AGENDA ITEM: **ZM10-008** - 5620 Glenridge Drive, Applicant: BTIC Glenridge, LLC,
To modify condition 3.i. of RZ06-055 to reduce the number of
specimen trees required to be saved from five (5) to four (4)

Agenda Item: **ZM10-008 5620 Glenridge Drive**, Request for a zoning modification to the conditions of Sandy Springs zoning case RZ06-055/U06-008/CV06-039.

ZONING MODIFICATION PLAN

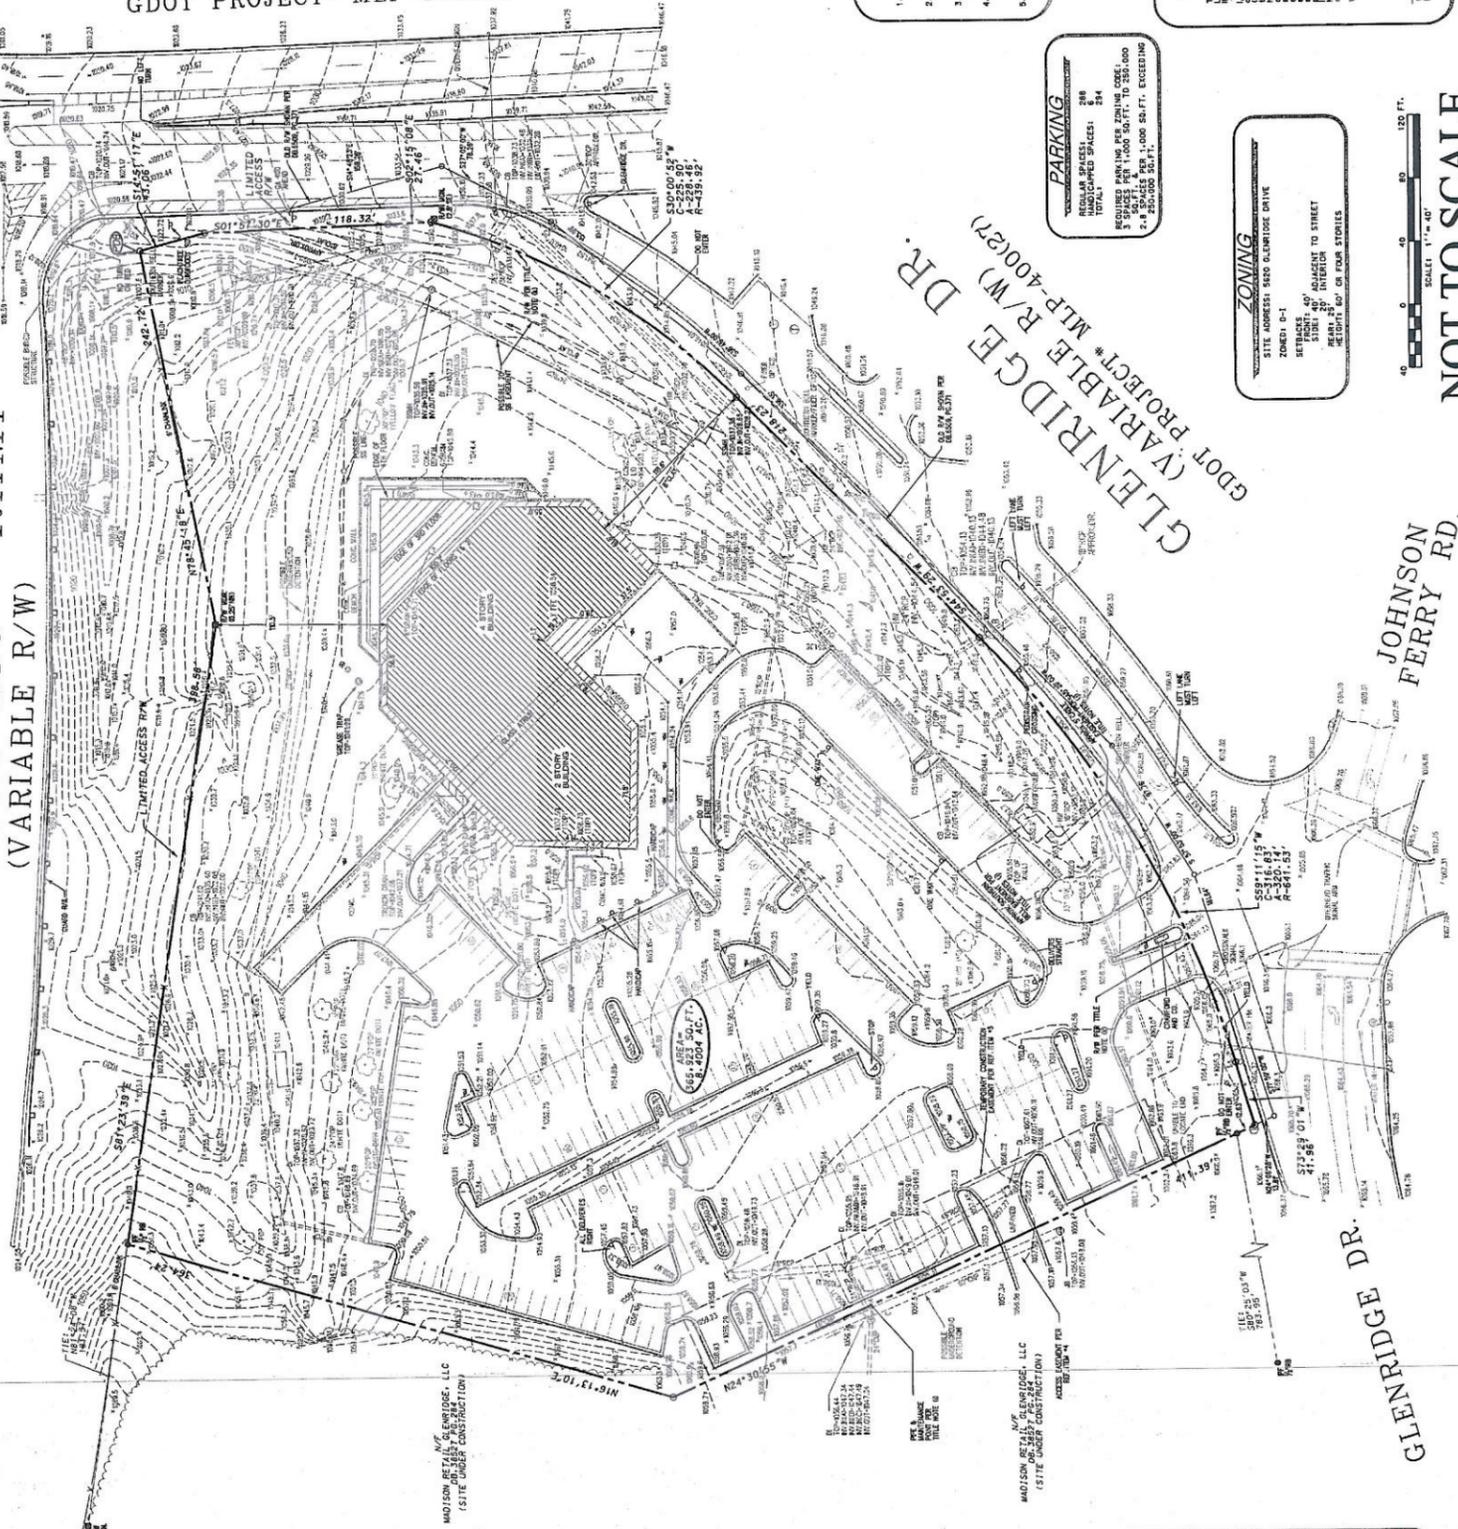
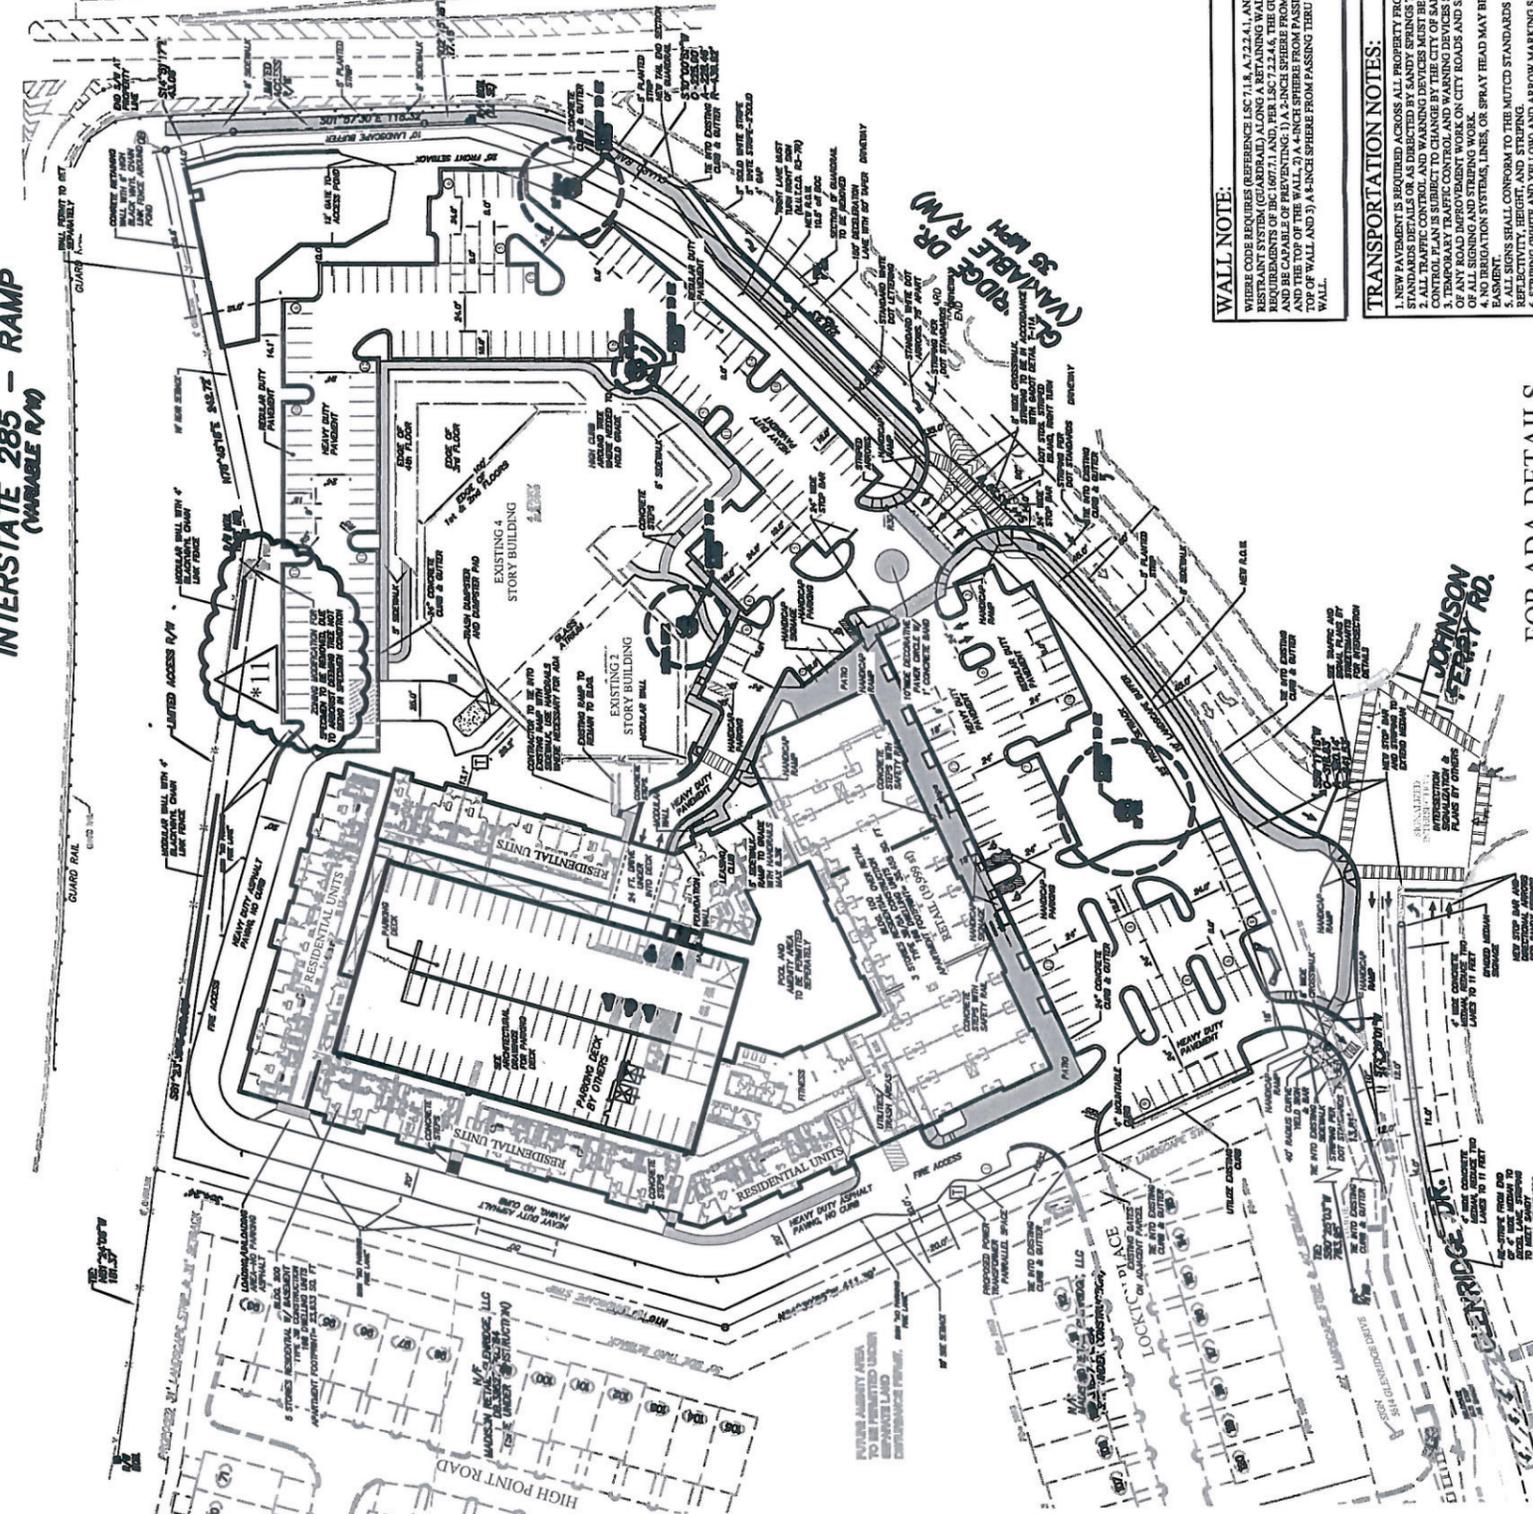
In the process of installing the BMP's on the site the contractor graded in the critical root zone of one of the specimen trees to be saved (30" pine). As per the Zoning Conditions for the site the applicant was required to save five specimen trees. The 30" pine was one of these trees.

On July 14, 2010 the contractor was issued a citation for violation of the Tree Conservation Ordinance section, 109-371 (c) 4 Non-approved encroachment into the critical root zone of a protected tree and non-compliance of the zoning conditions.

Sandy Springs Landscape Architect/Arborist	<ul style="list-style-type: none"> ▪ During construction the grading contractor graded into the critical root zone of one of the specimen trees (30" Pine) to be saved. The site super was cited and taken to court. If the MCC decides to approve the application it could be conditioned to providing additional canopy trees to mitigate the loss of the tree.
FIRE DEPT.	Sandy Springs Fire Protection Engineer	<ul style="list-style-type: none"> ▪ There are no Fire Department requirements that need to be addressed at this time.
TRANSPORTATION	Sandy Springs Transportation Planner	<ul style="list-style-type: none"> ▪ There are no Public Works requirements that need to be addressed at this time.
	Georgia Department of Transportation	<ul style="list-style-type: none"> ▪ There are no Georgia Department of Transportation requirements that need to be addressed at this time.

- i. The owner/developer shall retain at least ~~five (5)~~ **four (4)** of the existing specimen trees located on the subject property.

The zoning modification request is to lower the required (5) specimen trees to be saved, down to (4) specimen trees to be saved due to existing site conditions. In addition, the developer would like to install additional replacement trees equal to and above the amount of canopy cover of the 30-inch Pine tree that was removed. The developer will be installing replacement trees equaling 6,000 square feet of canopy cover, instead of just replacing the 4,417 square feet of canopy cover that was removed. Please see attached exhibit with revision clouds for the location of revised areas and new tree locations.
